April 15, 1993
LD-93-065

Docket No. 52-002

Subject: System 80+TM Safety Analysis Report Revisions

The attachments to this letter provide markups to CESSAR-DC, as required by NRC staff, for closure of the corresponding DSER issues. These markups, and others discussed with staff in the near future, will be printed as part of Amendment 0 in May, 1993.

Figure 10-1
Fault Tree for Core Damage Due to RCP Seal LOCA on SBO

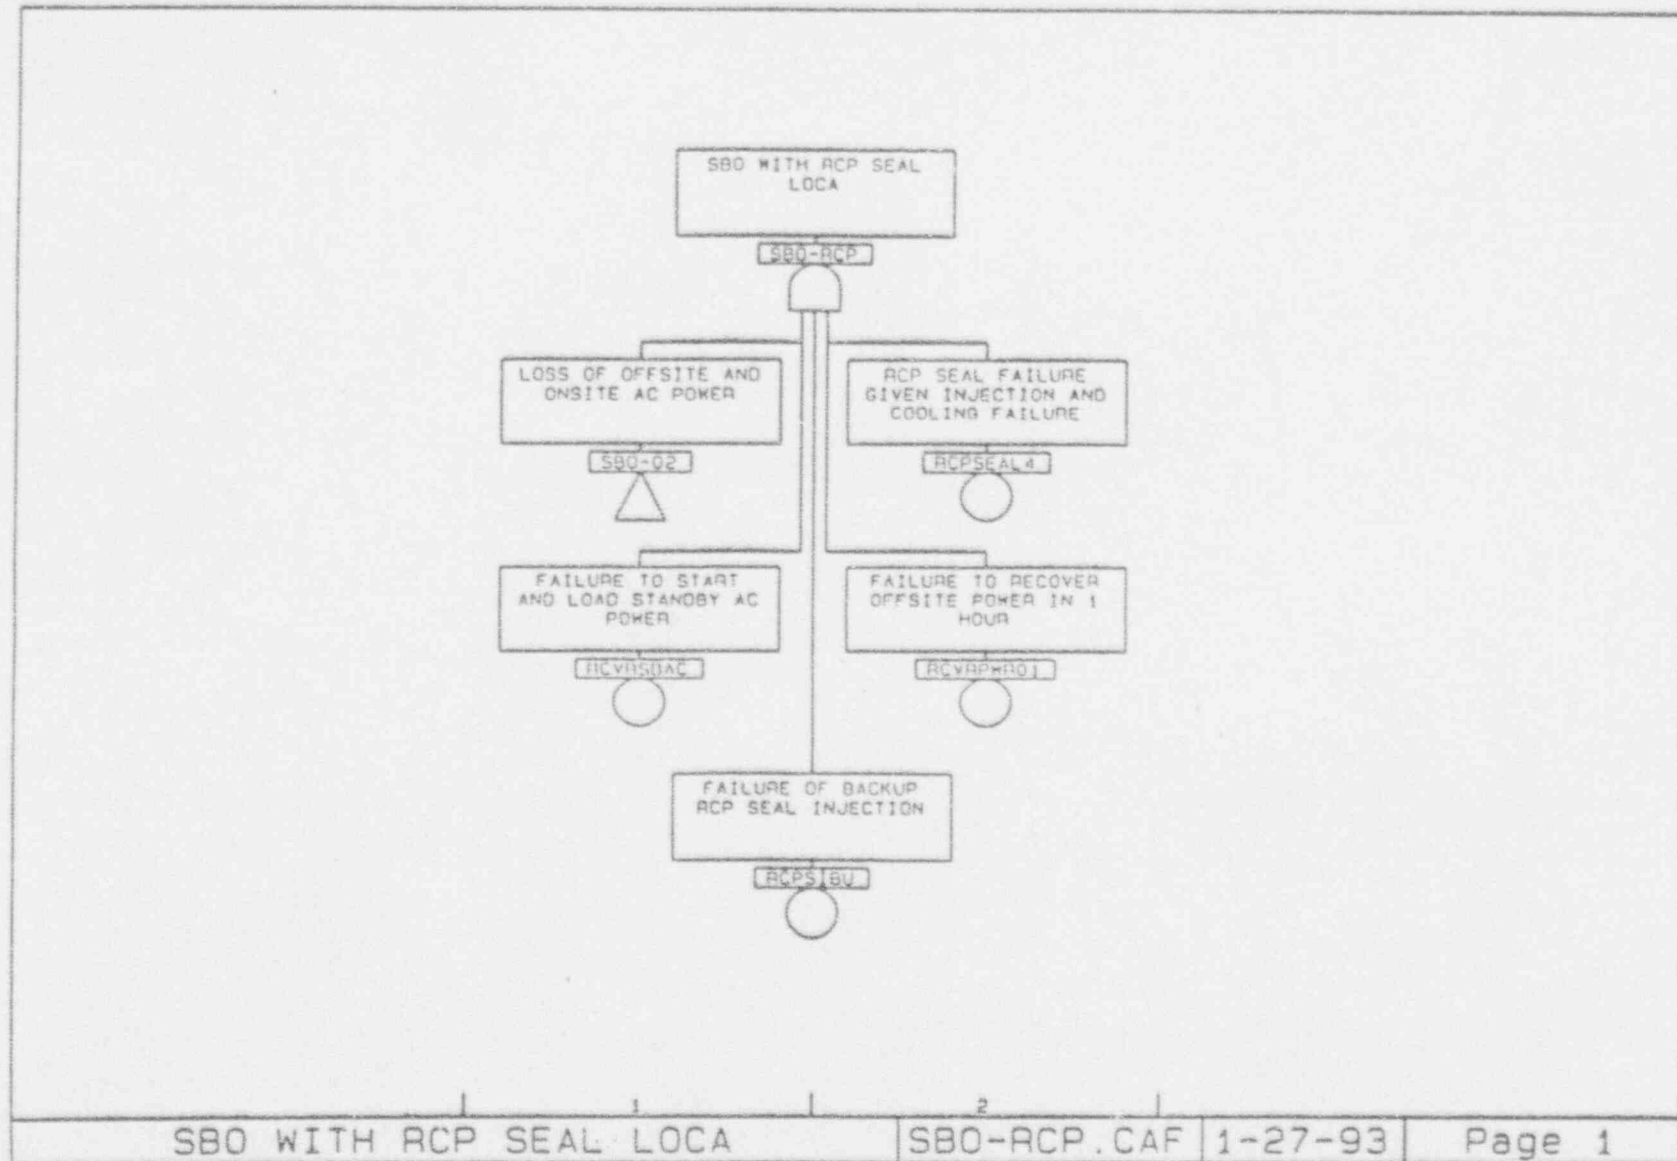
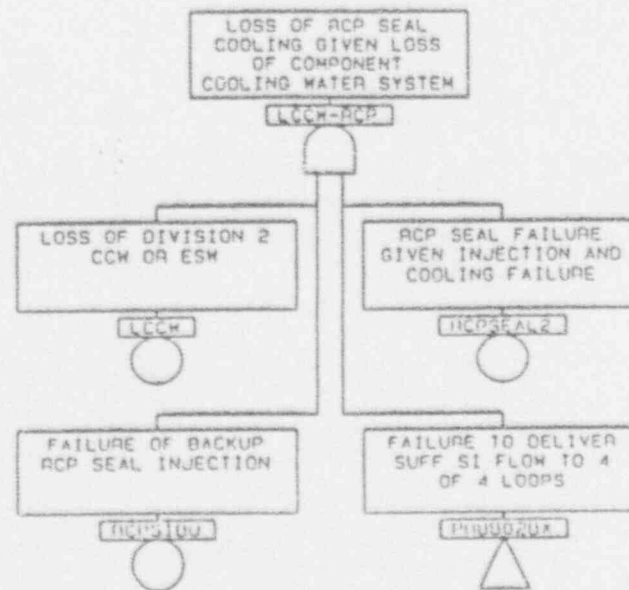
Attachment 5 provides revisions to Sections 19.10 to show the PRA's low sensitivity to the assumed reactor coolant pump seal failure probability. This attachment also provides PRA Levels 2 and 3 sensitivity studies, Section 19.14, and the summary of PRA insights, Section 19.15.

The fault tree presented in figure 10-2 was used to represent this sequence.
